Subject: Farmstead Development Plan
Jackson Pike
Grove City, Ohio
Control #201808290040

Grand Communities, LLC. (GCL) is pleased to submit revised plans of the above referenced project for your review.

The comments provided by Grove City dated December 31, 2018 have been addressed with this resubmittal. The plan updates are based on GCL's review of the comments and coordination meeting on December 19, 2018 with staff.

Exhibit D - Conceptual Signage Plan

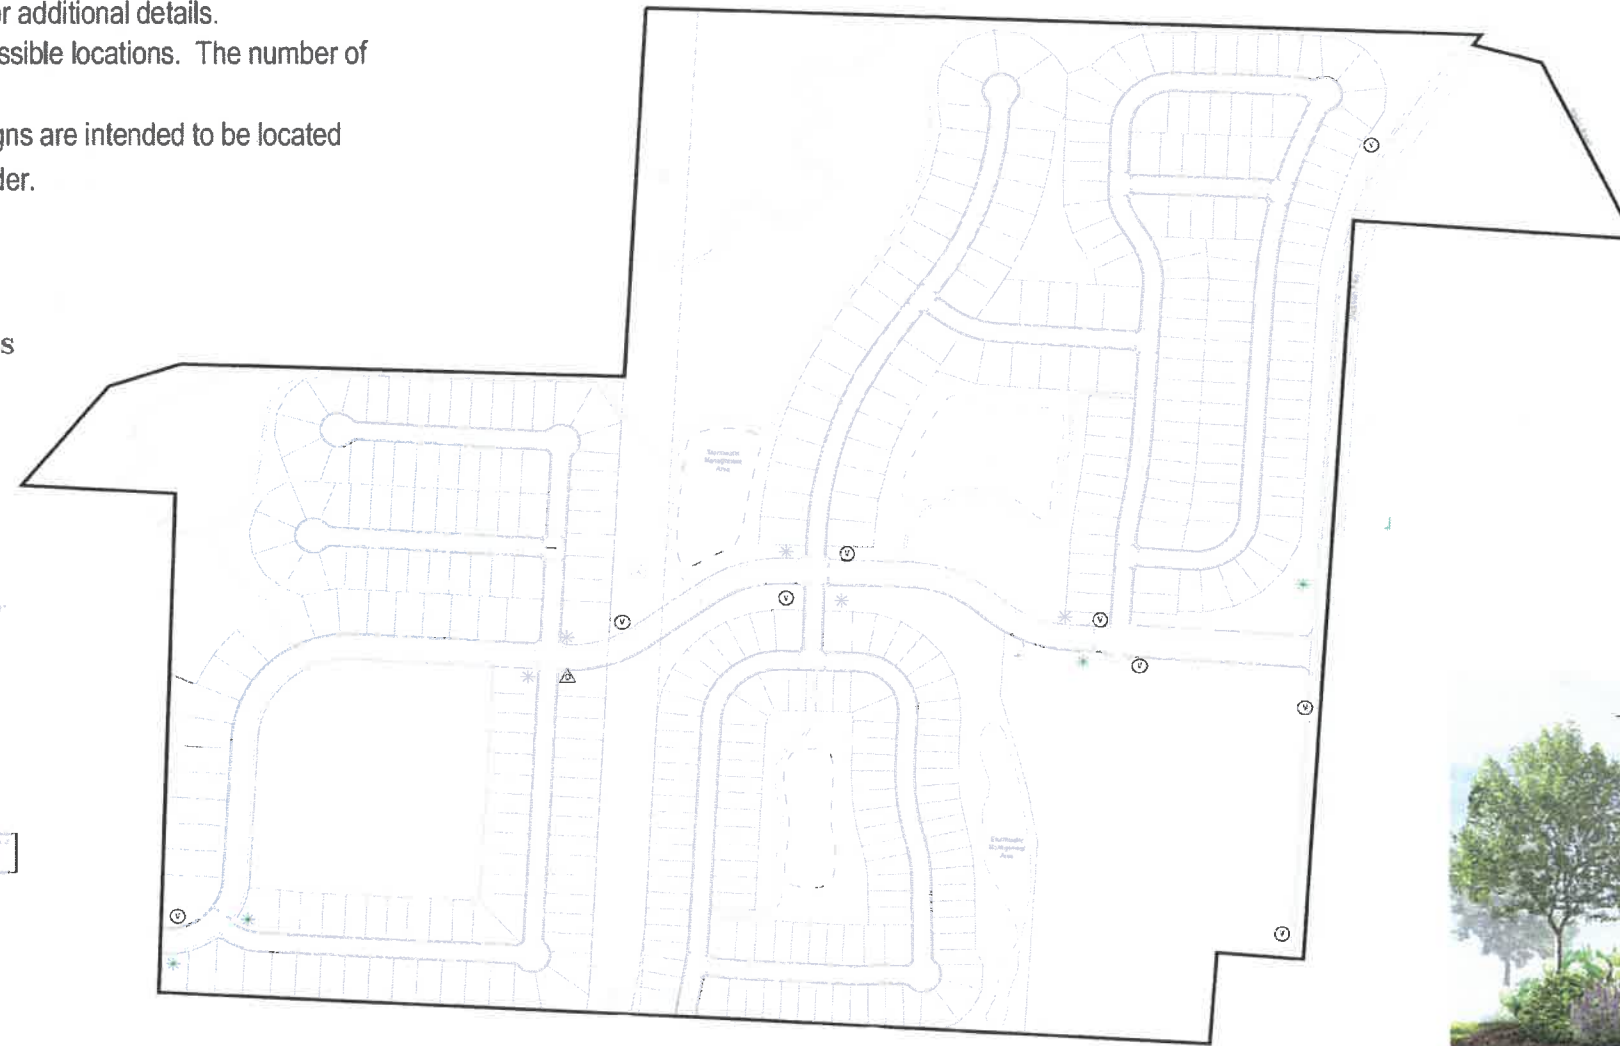
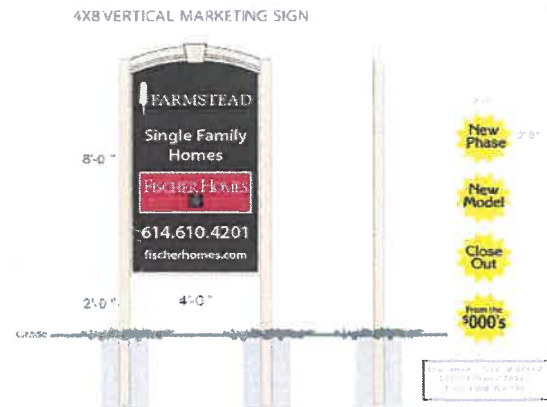
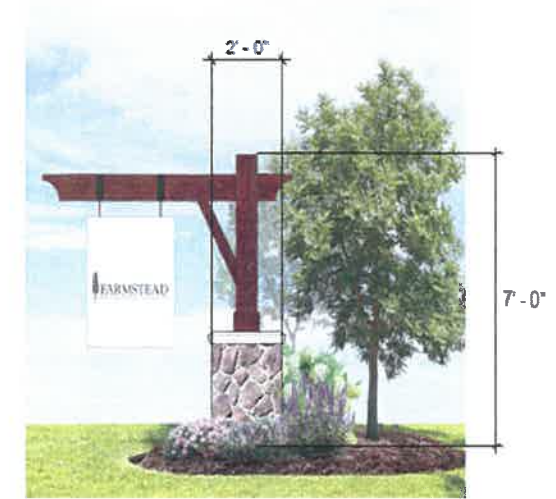
3. Show the location for each of the proposed signs (entry, sub-entry, amenity center, etc.) on the site plan.

11. Submit details for proposed signage for the main entries, for each sub-entry area, and for the amenity center (if proposed). Please note that signage is approved as part of the final development plan and the details need to include sign materials and colors, height, and square feet for the face/cabinet.

The proposed signs have been added to the plans.

Signage details for the main entry and sub-entries have been added to the plans.
